UNITED STATES PATENT AND TRADEMARK OFFICE

| APPLICATION NO. | FILING DATE | FIRST NAMED INVENTOR | ATTORNEY DOCKET NO. | CONFIRMATION NO. |
|--|-------------|----------------------|-------------------------------|------------------------|
| 10/624,454 | 07/21/2003 | Steven M. Casey | 020366-089500US | 5591 |

Office Action Summary

DETAILED ACTION

FIG. 2

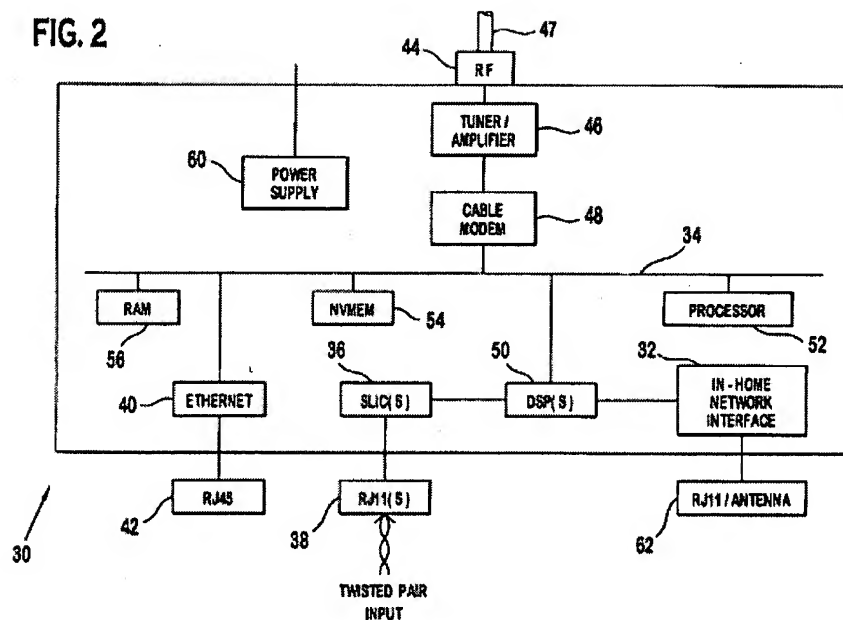
Regarding claim 2, Moore also discloses the isolation device and microserver are disposed within a common housing (Figure 2).

Regarding claim 6, Moore also discloses the isolation device, microserver, and addressable application device are disposed within a common housing (Figure 2).

Regarding claims 17, 32 and 44, Moore also discloses the microserver comprises a wireless microserver adapted to provide an interface between wireless communications within the customer premises to the external transport medium (RF connector 44 or antenna 62; Figure 2).

FIG. 3

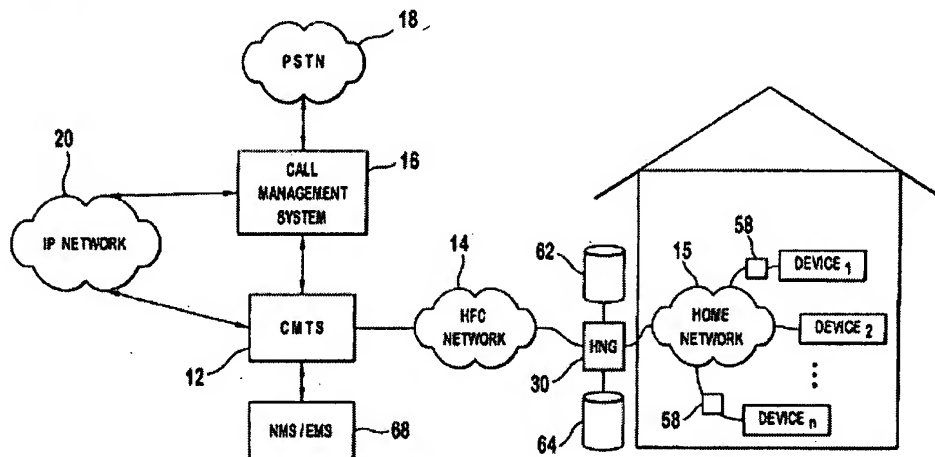
Regarding claim 3, Moore also discloses the common housing (30) is disposed on an exterior wall of the customer premises (Figure 3).

Regarding claim 5, Moore also discloses the addressable application device is disposed external to the customer premises (Figure 3).

FIG. 8

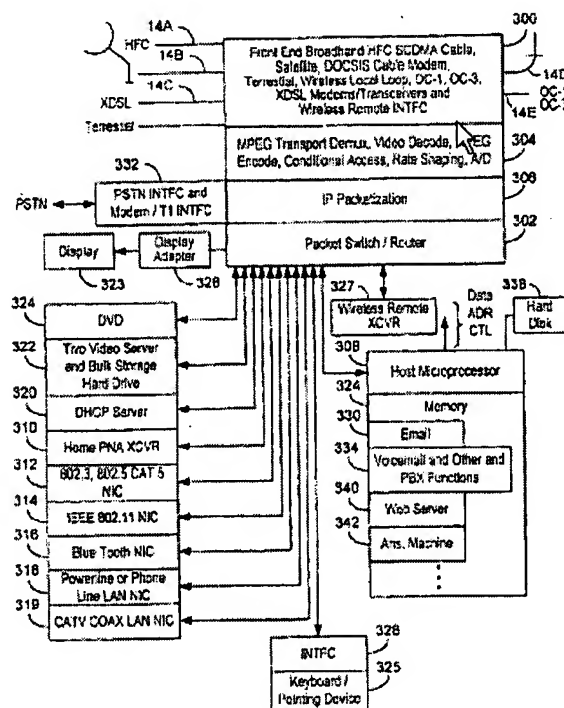
Regarding claims 9-11, 26 and 38, Moore discloses substantially all the claimed limitations, except a dynamic host configuration protocol microserver adapted to manage an internet-protocol address assignment to a device coupled with the internal transport medium.

As shown in Figure 8, Rakib teaches a home gateway comprising a DHCP server 320 assigns addresses to clients on the LAN and in the gateway (col. 27: lines 16-17; Figure 8).
